CITY OF West Linn

PLANNING MANAGER DECISION

FILE NO.: WAP-19-01

REQUEST: Request for a Water Resource Area (WRA) hardship allowance to construct a single-family home at 4327 Kelly Street

Figure 2

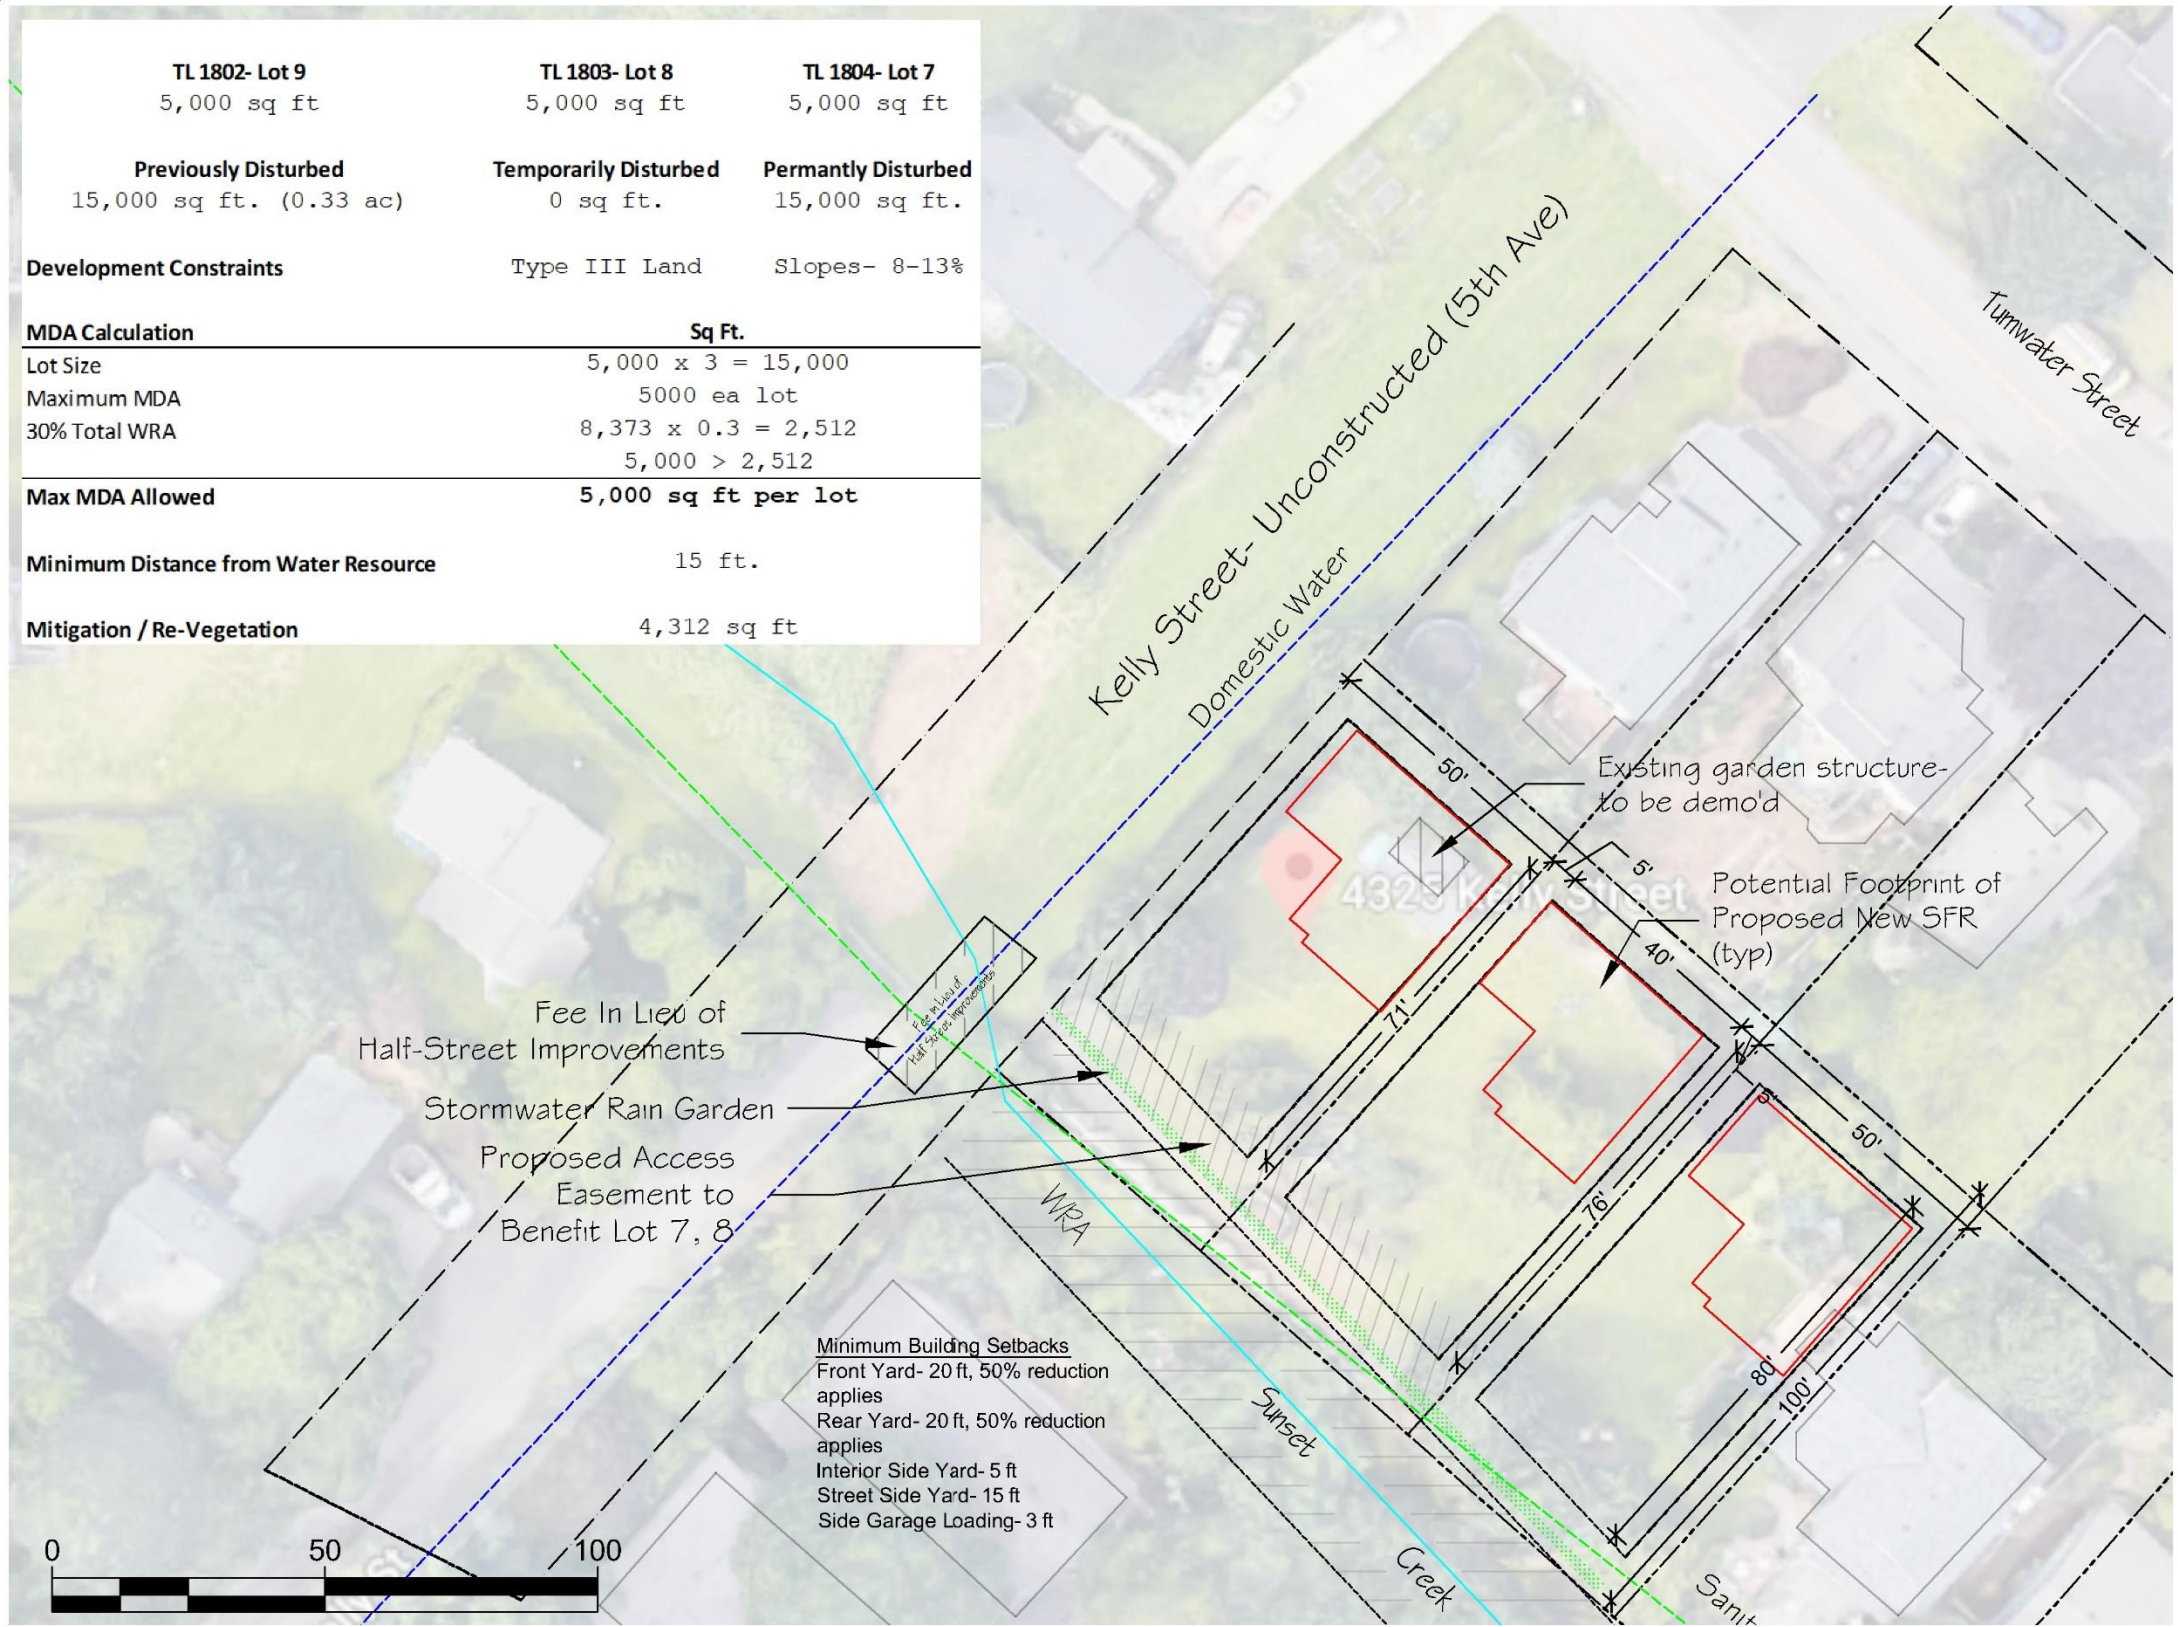
Staff Finding 10: The applicant has indicated a house footprint on the subject property at the maximum distance away from the resources area while still meeting setback requirements (See sheet 2 of the applicant's submittal). These criteria are met.
